UNITED STATES PATENT AND TRADEMARK OFFICE

APPLICATION NO.	FILING DATE	FIRST NAMED INVENTOR	ATTORNEY DOCKET NO.	CONFIRMATION NO.
10/634,699	08/05/2003	Jeong-Sik Cho	5000-1-410	7562
33942	7590	03/17/2005	EXAMINER	
CHA & REITER, LLC 210 ROUTE 4 EAST STE 103 PARAMUS, NJ 07652			LEPISTO, RYAN A	
			ART UNIT	PAPER NUMBER
			2883

Office Action Summary

DETAILED ACTION

Fig.4

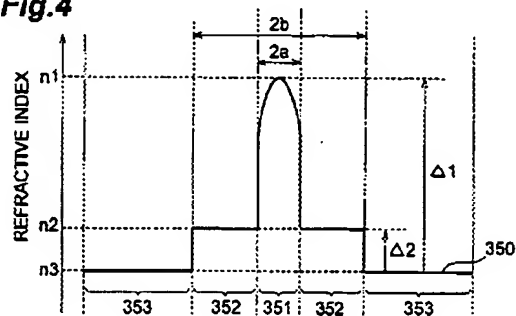
Kato et al teaches a wide-band dispersion controlled optical fiber (column 2 lines 11-17) characterized with the refractive index profile from Fig. 4 and the parameters from Fig. 11 and 12 shown below:

As is shown in the figure and table above (see also column 11 lines 11-64, column 20 lines 18-57 and column 21 line 39 through column 22 line 16) all embodiments (3, 15 and 17) teach dispersion at 1300 nm (O-band) between -12 and -4 ps/nm/km, dispersion at 1600 nm (L-band) between 8 and 14 ps/nm/km and positive dispersion at 1550 nm (C band), effective cross-sectional areas at 1550 nm of less than $75 \mu\text{m}^2$, while embodiments 3 and 15 teach a cut-off wavelength less than 1285 nm, embodiments 3 and 17 teach a zero dispersion wavelength below 1430 nm and embodiments 15 and 17 teach dispersion slopes at the zero dispersion wavelength of less than $0.074 \text{ ps/nm}^2/\text{km}$. Embodiment 3 teaches a bending loss at 1550 nm when wound at a diameter of 32 mm of 0.006 dB per turn, embodiment 15 – 0.00006 dB per turn and embodiment 17 – 0.00002 dB per turn.

All embodiments (3, 15 and 17) teach an internal core with a diameter d_1 (Fig. 4, 2a) (either $6.4 \mu\text{m}$, $4.8 \mu\text{m}$ or $7.5 \mu\text{m}$) and refractive index n_1 (Fig. 4), an external core which encloses the internal core having diameter d_2 (Fig. 4, 2b) (either $16 \mu\text{m}$, $15.1 \mu\text{m}$ or $29 \mu\text{m}$) and refractive index n_2 wherein the refractive index n_2 of the external core gradually decreases from n_1 away from the center of the internal core (cone shaped section, Fig. 4), an internal clad which encloses the external core and has a diameter d_3 (Fig. 4, 353) and refractive index n_3 resulting in d_1/d_2 relationships of 0.4, 0.32 and 0.26 respectively and wherein $n_1 > n_2 > n_3$ and Δ_1 is 0.60%, 0.65%, 0.61% respectively and Δ_2 is 0.10%, 0.06%, 0.10% respectively.
